INSPECTION REPORT
Sedimentation Structure
N1-AC
Kayenta Mine
Navajo County, Arizona
for
PEABODY COAL COMPANY

Dames & Moore
10139-011-22

EXISTING
MAXIMUM CROSS-SECTION
A-A'
N1-AC

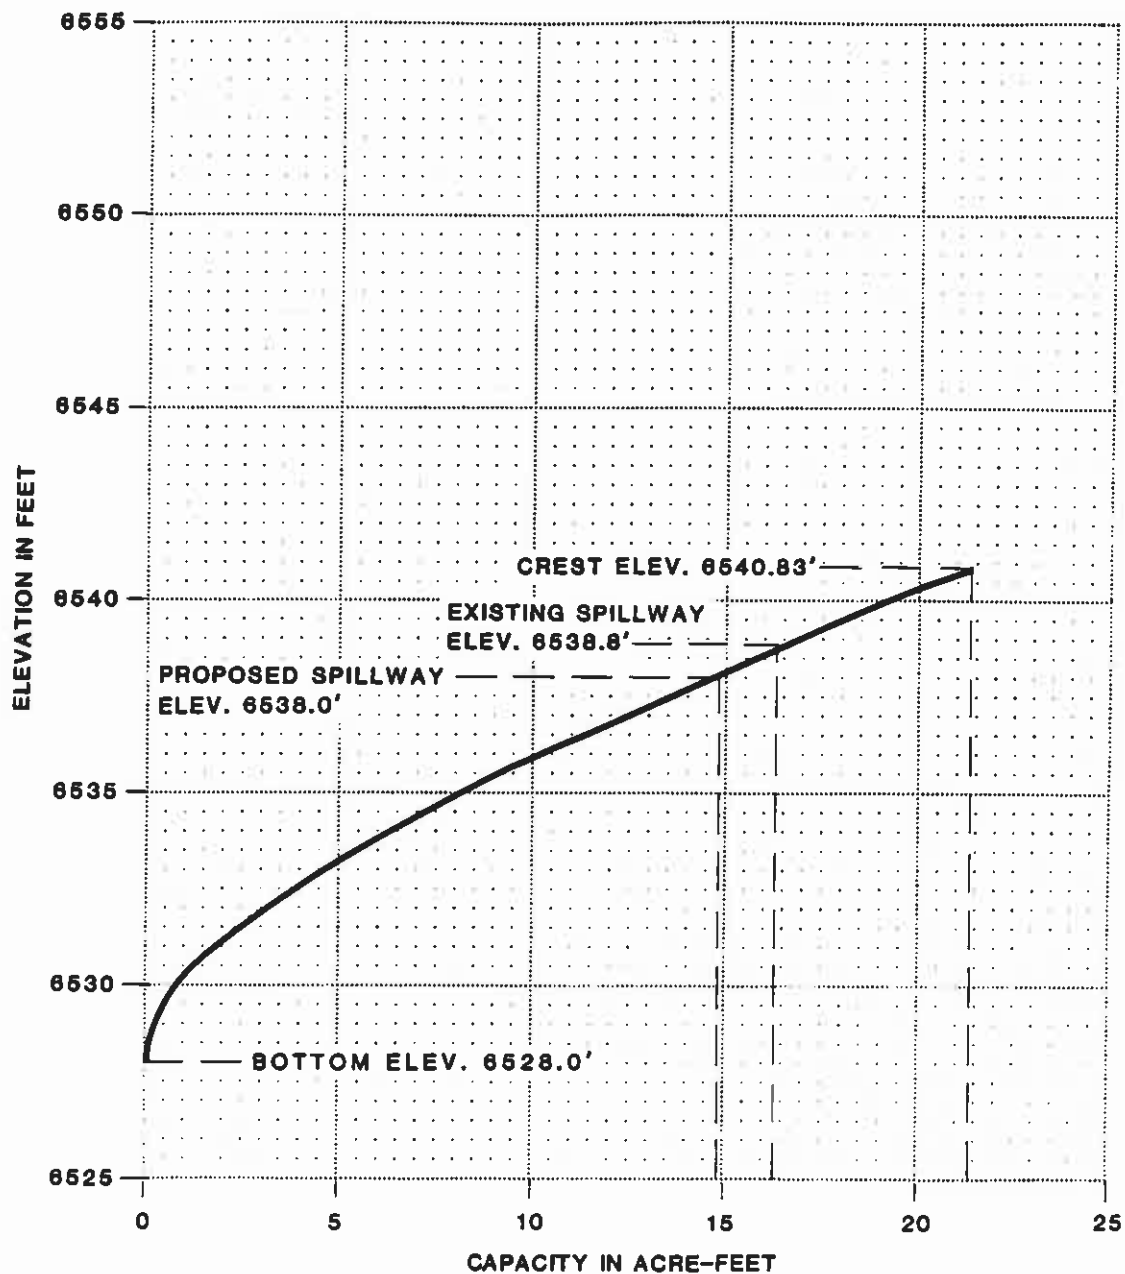
The inspection of Structure N1-AC indicated that the geotechnical problems consist of rill on the upstream and downstream slopes; the side slopes of the spillway and outlet channel; and the right abutment and cracks at the upstream edge of the crest towards the left abutment. Correction of erosion is considered a periodic maintenance task and does not require

remedial action. The cracks in the crest should be repaired by excavating to the bottom of the cracks and replacing with compacted fill.

**SPILLWAY AND
OUTFLOW CHANNEL
CROSS SECTION
N1-AC**

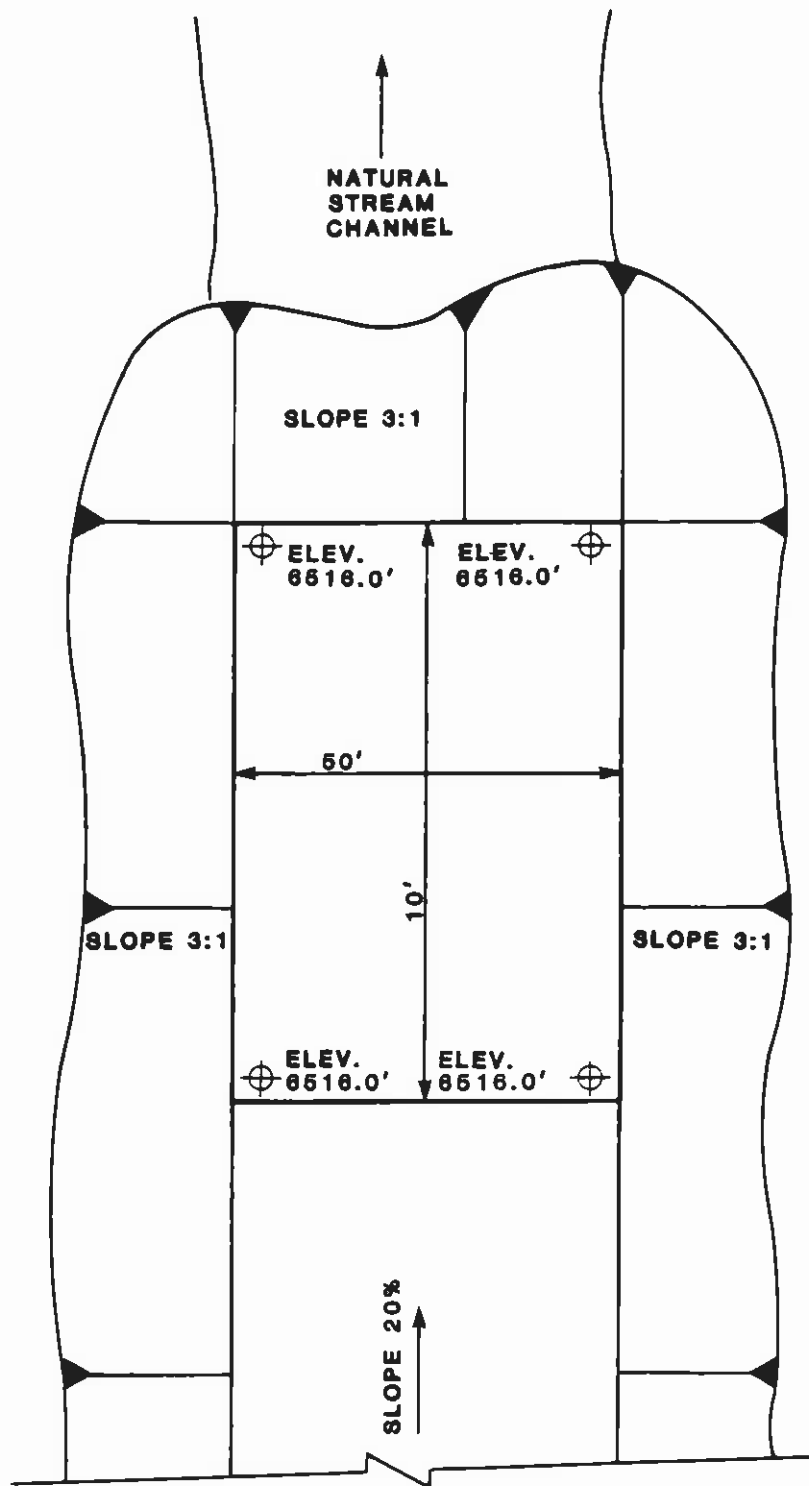
The storage capacity of Structure N1-AC is adequate but the spillway capacity is inadequate. The structure does not have an adequate outflow channel. The bottom elevation of the existing spillway channel should be lowered to elevation 6538.0 feet while maintaining the bottom width of 50 feet as shown on Plate 5. A trapezoidal outflow channel with the same bottom width as the spillway should be constructed along the alignment shown in Plate 1. The channel profile is shown in Plate 4 and required dimensions are shown in Plate 5 and Plate 6. The spillway, outflow channel and stilling basin should be protected against erosion using geotextile and riprap as shown in Plate 5.

$D = 2.7'$

LENGTH = 50'

FLOWLINE ELEV. = 6538.00'

$D = 1.5'$
